Update Project Proposal: SFF-TA-1016 Internal Unshielded High Speed Connector System

Presented: 2026-04-24

Presenter: Zhineng Fan [Amphenol]

Add Enhanced Receptacle Connector

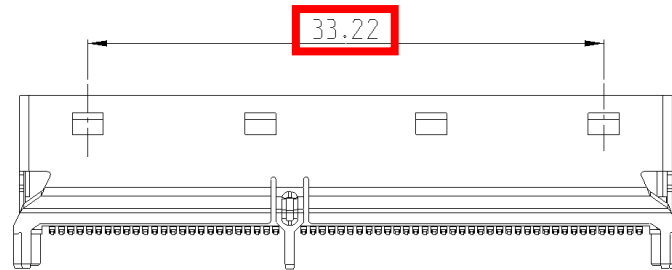
- Add 11mm wide latch holes to enhanced 74P receptacle

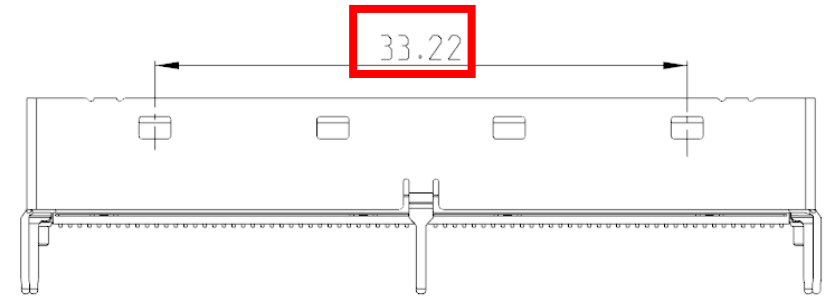
- Add 33.22mm wide latch holes to enhanced 124P receptacle connector

- Add 33.22mm wide latch holes to enhanced 148P receptacle connector

Add Enhanced Plug

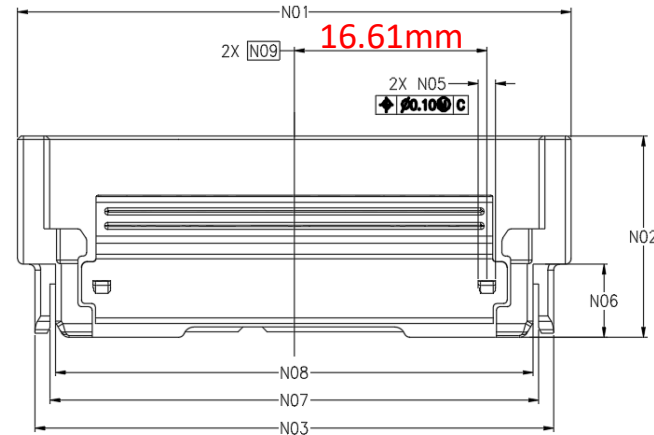
- Enhanced 74P plug with 11mm wide latch

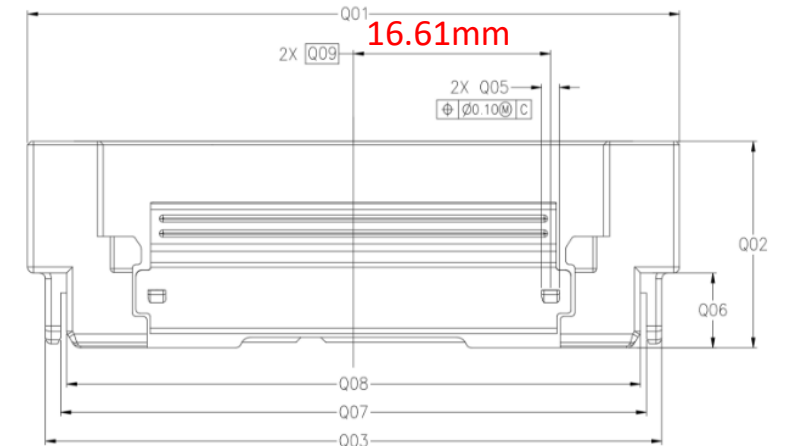
- Enhanced 128P plug with 16.61mm wide latch

- Enhanced 148P plug with 16.61mm wide latch
